Subject: Submittal of the Response to the Notice of Disapproval for the Investigation Work Plan for Upper Sandia Canyon Aggregate Area and Revision 1

Cross-Reference of NMED NOD Comments and Revisions to Upper Sandia Investigation Work Plan

Figure 4.2-1 Map Q site location

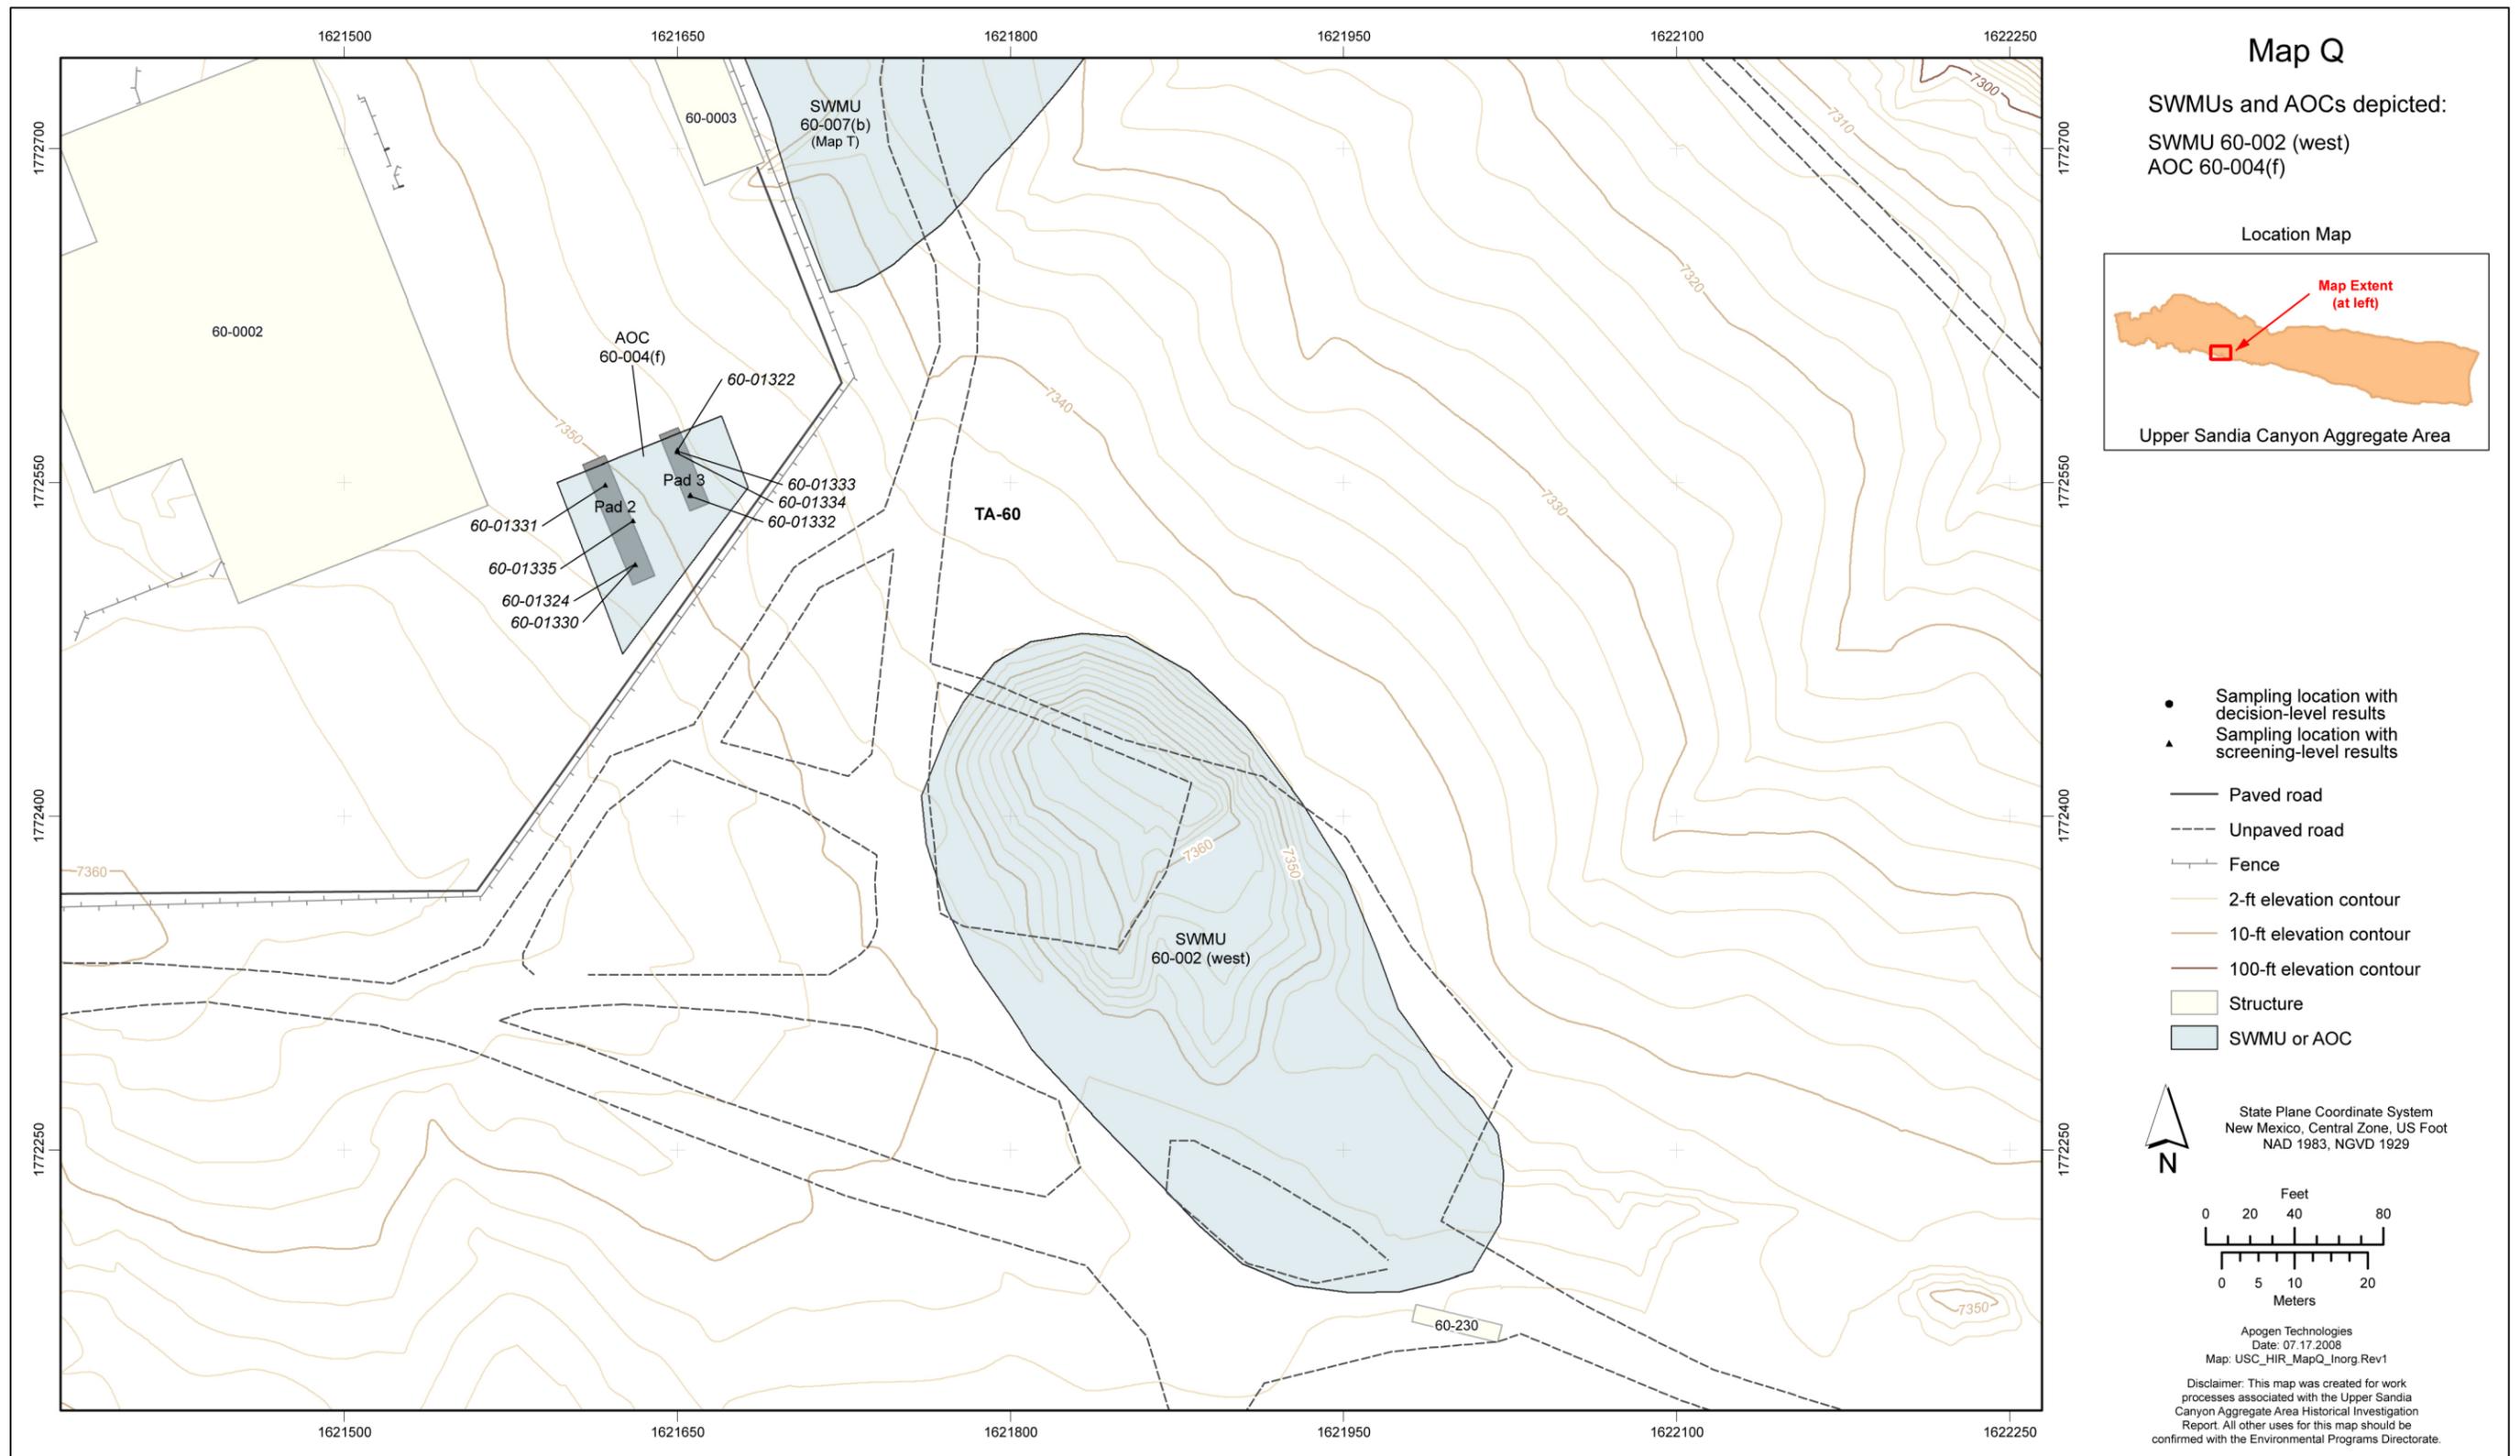
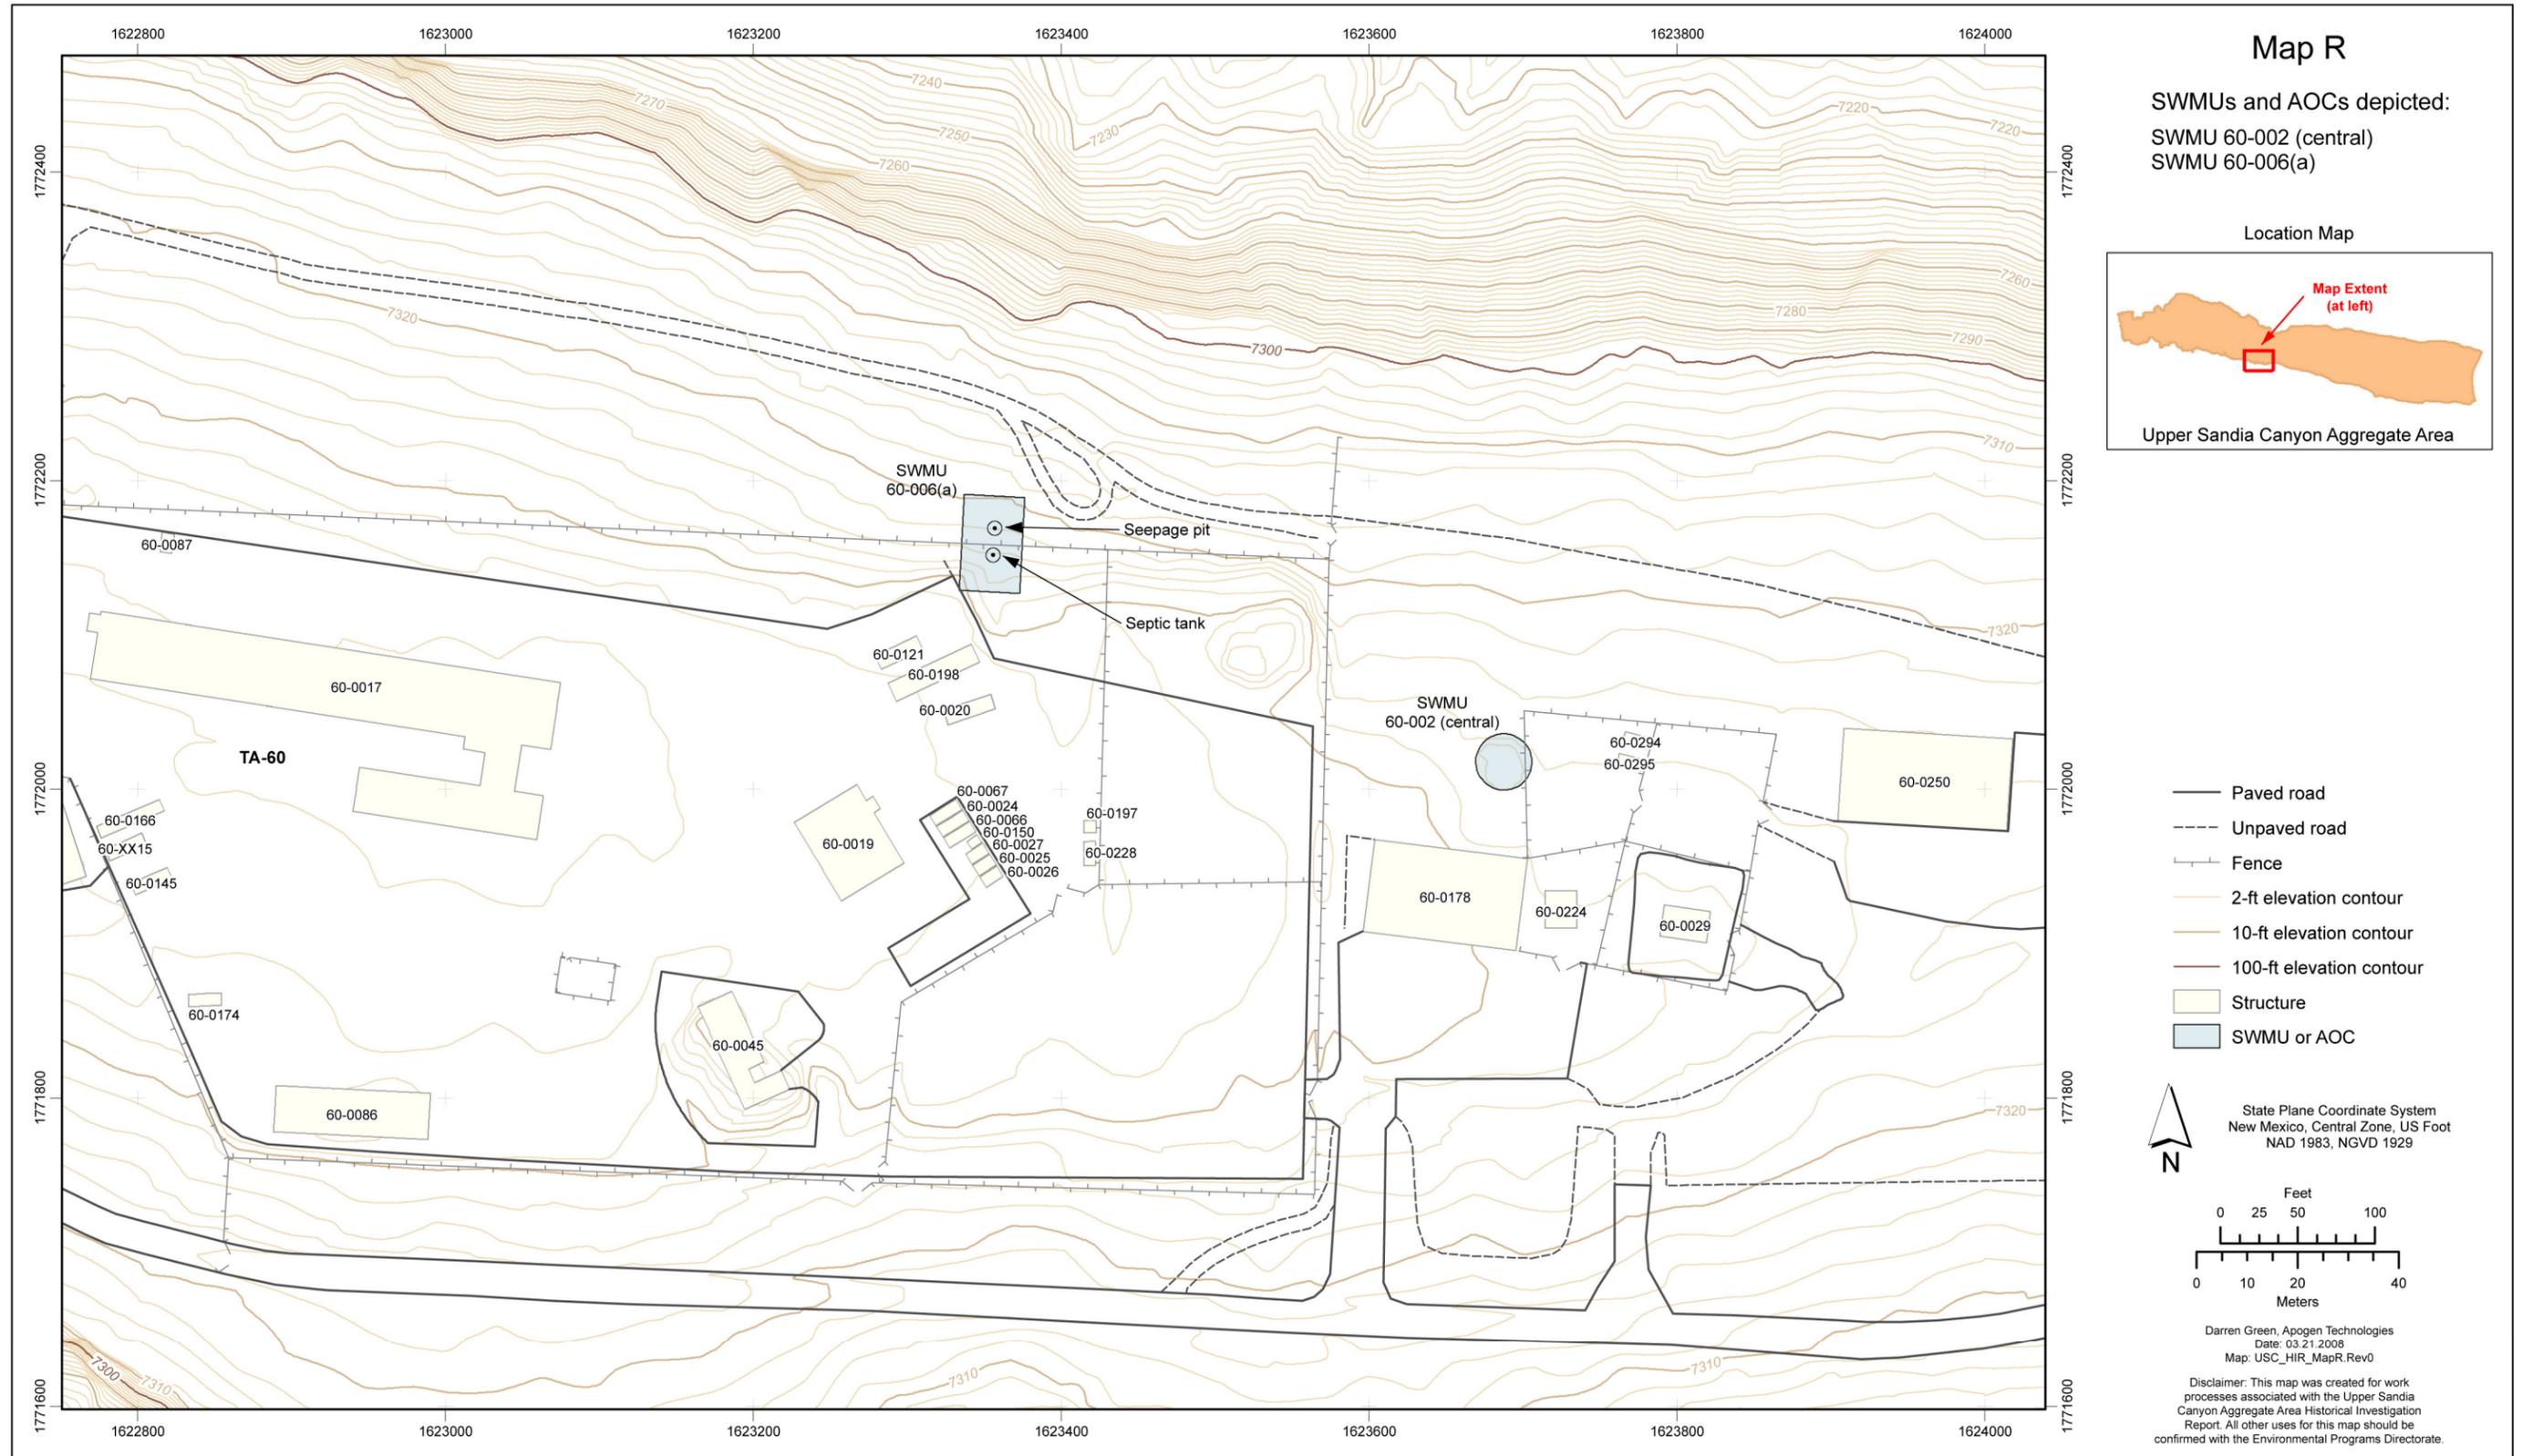
The Permittees discuss sampling locations associated with Pad 2 and Pad 3, but did not indicate the location of Pad 2 and Pad 3 on Figure 4.2-1. Revise the figure to indicate location of the pads. Mercury was detected above BV in four tuff samples, not three as stated (i.e., from locations 60-01330, 60-01331, 60-01332, and 60-01335). Revise the text accordingly. Tritium was detected in soil, tuff, and sediment samples during RFI activities conducted in 1994. Tritium analysis must be included for all samples collected at AOC 60-004(f).

34. Figures 4.2-1 to 4.2-5 have been revised to show former storage pads 2 and 3.
